TA-2016 – Downtown Streetscape Improvements Phase II Transportation Alternatives Design Assistance Program (TAP)

Borough of Pennington, Mercer County
NJDOT Local Aid District # 3
Design Consultant: NV5

In-Person Public Information Center • Tuesday, March 28, 2023 COMMENT RESOLUTION SUMMARY

Annotated plan received via email from commenter

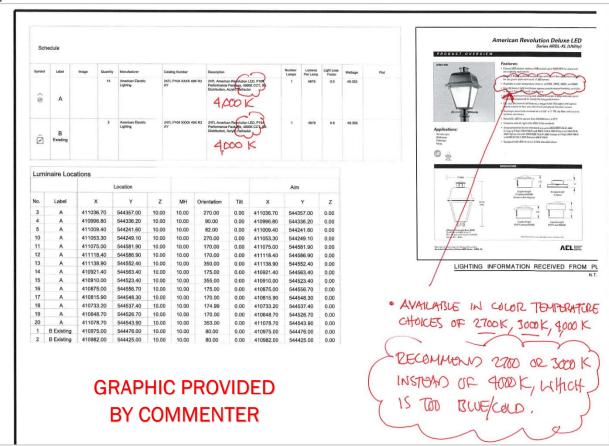
I note on the consultant boards that specified streetlamps include 400K color temperature lamping. I think this is too cold and blue-ish and will detract from street character of historically appropriate street lamps. Attached Lighting information from the same presentation board indicates that standard 2700K and 3,000K color temperatures are also available. 2700K would be preferred, but either 2,700K or 3,00K would be acceptable.

Following coordination between Pennington Borough and Public Service Electric and Gas (PSE&G), PSE&G is planning to install LED replacement lights for the Phase 1 portion of the project, which will match the proposed pedestrian lights in Phase 2 (this project) - the existing phase 1 lights (100W High Pressure Sodium [HPS]) will be replaced with the 4000K LED lights, since PSE&G will no longer stock and maintain the HPS Post top lights.. It is the understanding of NV5 that PSE&G only stocks 4000K LED lights in the post top Dayform Traditionaire luminaire for cost effectiveness and ease of maintenance. The 4000K LED (4,818 Lumens) is

more energy efficient (better light output) than the 2700K LED (4,360 Lumens) and 3000K LED (4,476 Lumens) for the same wattage (46W). While the Dayform Traditionaire luminaire is available from the manufacturer with 2700K and 3000K LEDS, PSE&G will not be able to maintain the luminaires for the reasons stated above.
